WCAP-16793-NP, Rev.0 (Non-Proprietary)
Project No. 694

March 2, 2009

OG-09-84

Subject: Pressurized Water Reactor Owners Group
Responses to the NRC Request for Additional Information (RAI) on WCAP-16793-NP, "Evaluation of Long-Term Cooling Considering Particulate, Fibrous and Chemical Debris in the Recirculating Fluid" (PA-SEE-0312)

—— SWITCH OVER TIME
- - - BOILOFF RATE
- - - CORE INLET FLOW

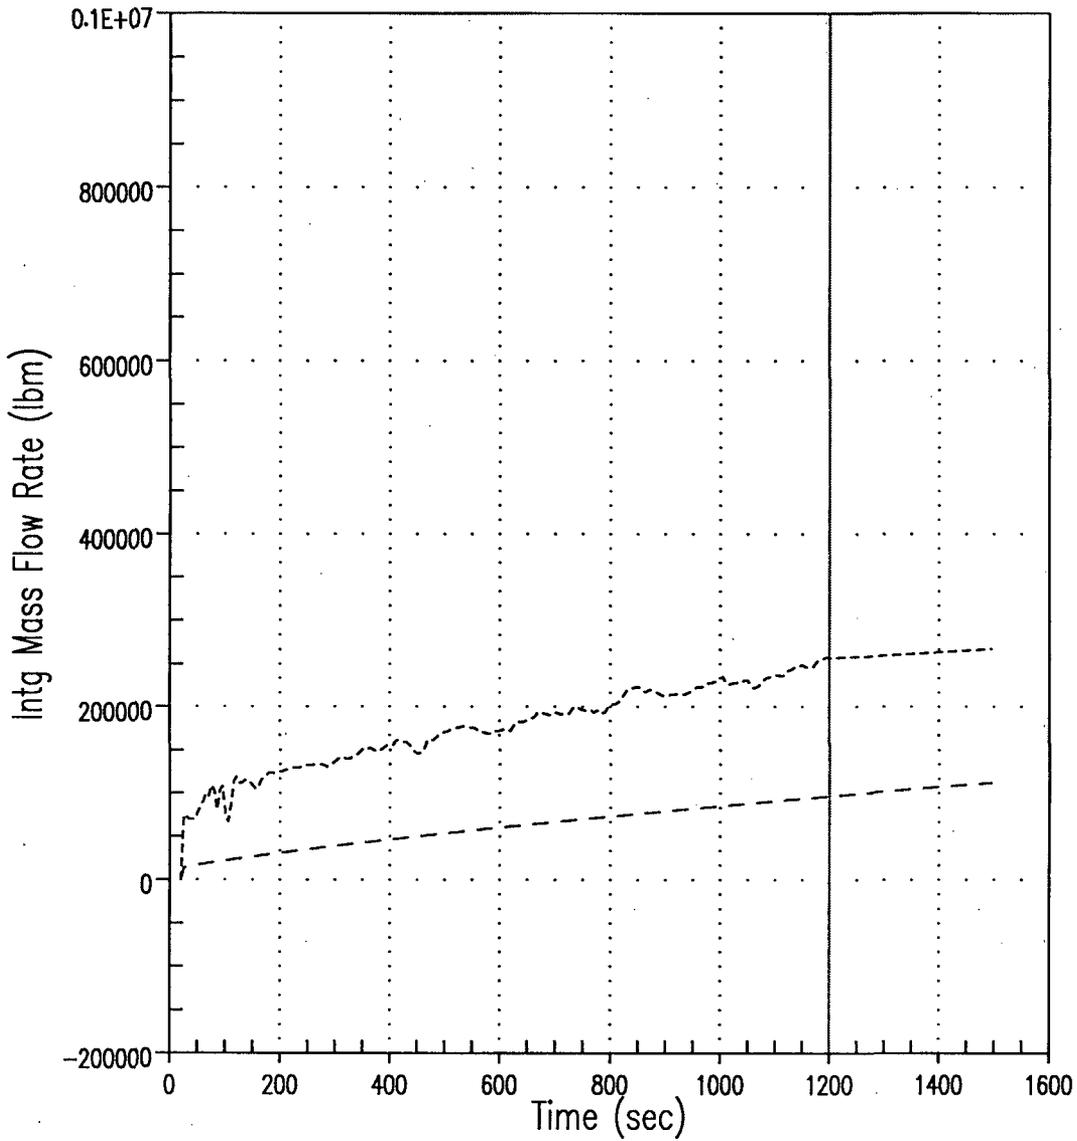
- 1) WCAP-16793-NP, Appendix B, presents analyses of the effect of core inlet blockage using the WCOBRA/TRAC analysis code. Since the report was prepared additional analyses have been performed to determine the blockage level that would reduce core flow below that necessary to match coolant boil-off. Please provide documentation of the additional analyses that have been performed, including figures, for the integrated core inlet and exit flow, peak cladding temperature, core collapsed liquid level, core exit void fraction, and core pressure drop for the bounding conditions. The results should be presented for each case analyzed up to and including the blockage level for which boiloff is no longer satisfied.

The first flow reduction run performed reduced the hot channel (Channel 13) flow area by 50%, which yields a total core inlet flow reduction of 99.7% compared to an unblocked core. The requested plots for this case are shown in Figures 1 through 7. Figures 1 and 2 show comparisons of the integrated core inlet flow and the core boil-off rate. As shown, even with the increase in core blockage, the flow that enters the core is still in excess of the boil-off rate. Figure 3 displays the integrated liquid flow at the core exit. The figures illustrate that, although liquid in excess of that needed to keep the core quenched enters the core, every little liquid flow is present at the core exit after the blockage occurs. The Peak Cladding Temperature (PCT) is shown in Figure 4. There are no significant PCT excursions after the core is blocked. Figure 5 displays the collapsed liquid level of the average assembly core channel (Channel 11 of Figure 6.3.4-3 in Reference 1). The figure shows that the collapsed liquid level drops slightly at the time blockage occurs, however, the liquid level continues to increase even after the blockage to the hot channel (Channel 13) is fully implemented at 1230 seconds. The void fraction at the core exit shown in Figure 6 again illustrates that liquid is present at the top of the core which shows the flow that enters the core after blockage occurs is still in excess of the boil-off rate. The core pressure drop is displayed in Figure 7. The figure displays an increased pressure drop of roughly 2 psi as blockage at the core inlet is increased. As the conditions in the Reactor Coolant System (RCS) adjust to increase in core blockage, it is noticed that the core pressure drop fluctuates consistent with the core liquid level.
